Planning & Development Services

DB-15-52 SUB

**Design Plat Review to allow a Cluster Subdivision containing 24 lots and associated common facilities on 4.798 Acres.
Zoned: RSF-4 (Single-family Residential).**

Legistar No.150714

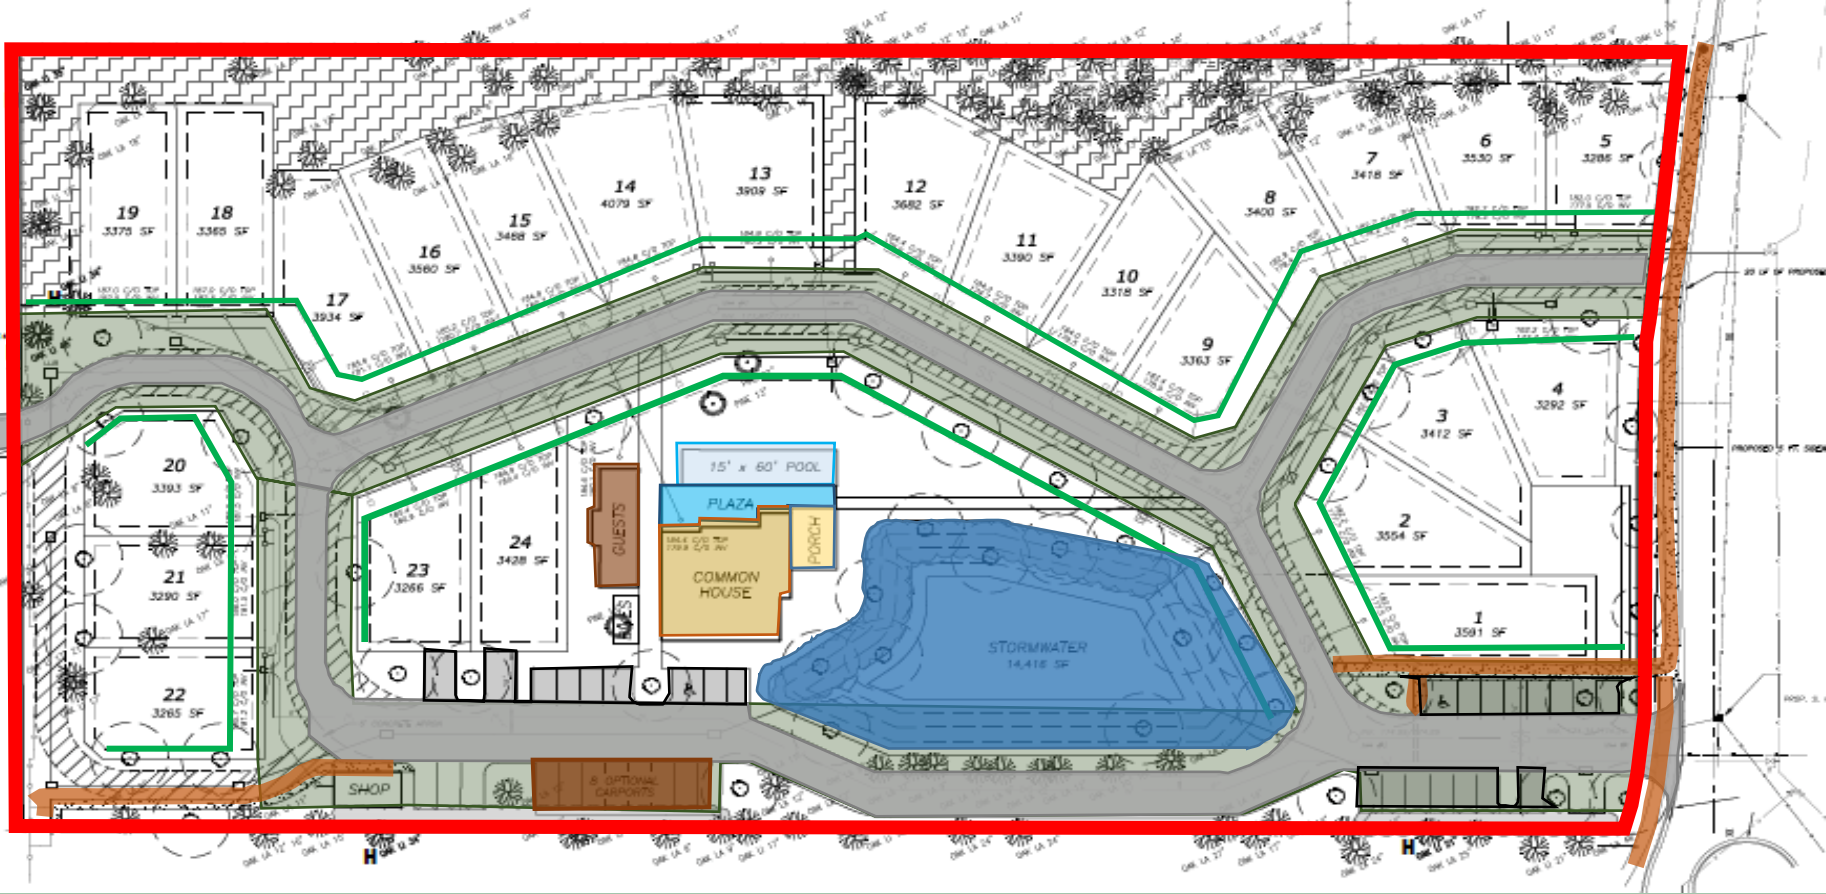
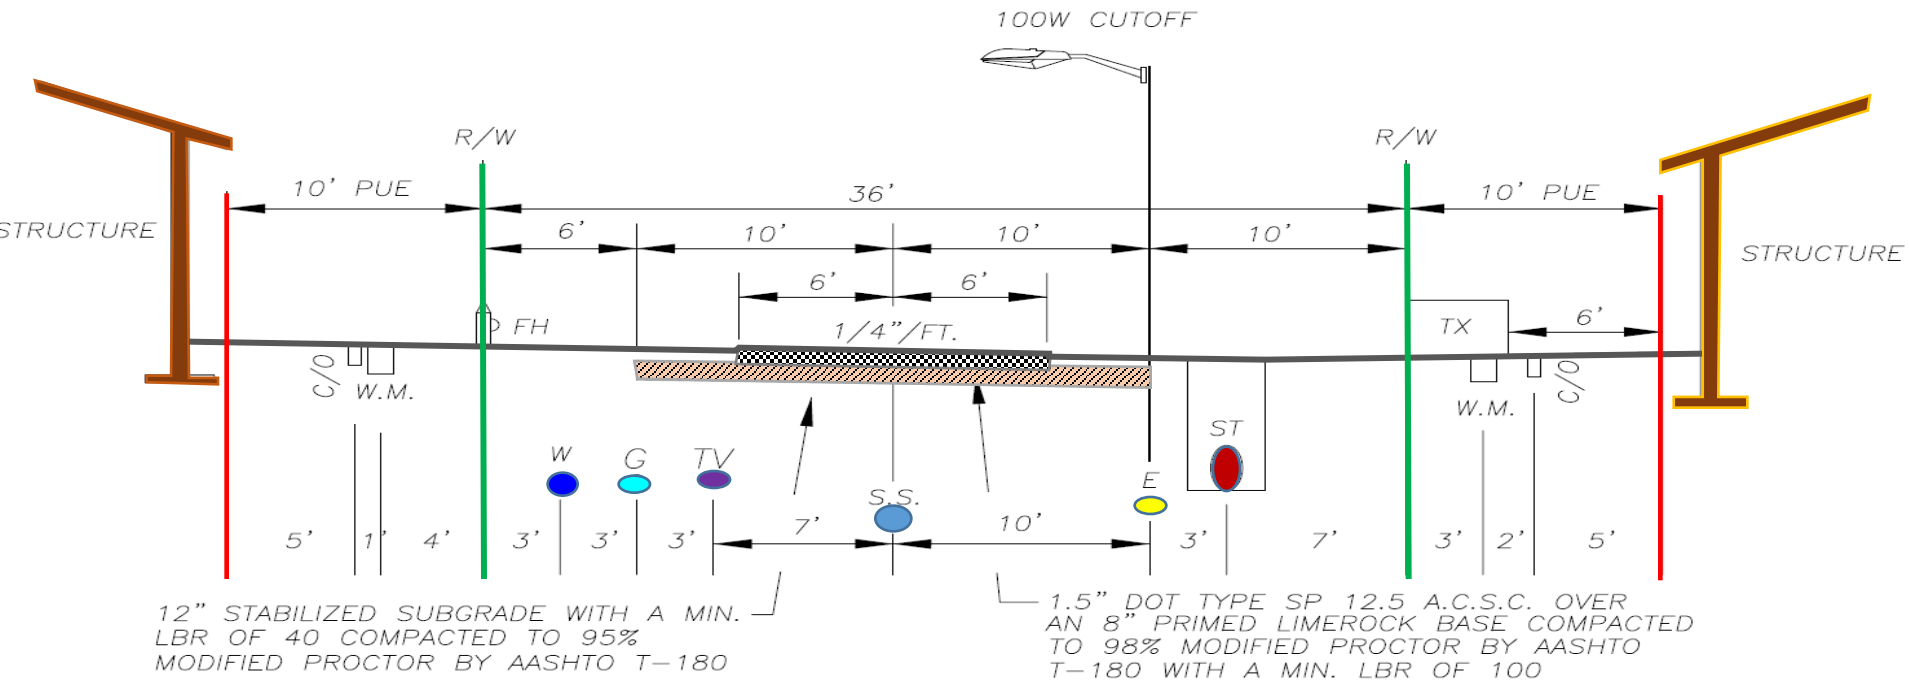
- (1) The minimum right of way width to be 30 feet instead of the required 50 feet.
- (2) Reduction in the minimum pavement width to 12 feet along the frontage road that will not have traffic and 6 feet along the minor streets off the frontage road. There will be a minimum of 20 foot stabilized area along all street areas so that emergency vehicles and utility vehicles can travel on them. The vehicular area will have a drive width between 18-24 feet.
- (3) No sidewalks along the streets which will be used as walkways. Traffic will not be allowed on the main loop road except for emergencies or special circumstances.
- (4) Parking along the main entrance street in order to allow for pedestrian traffic throughout the remainder of the streets.
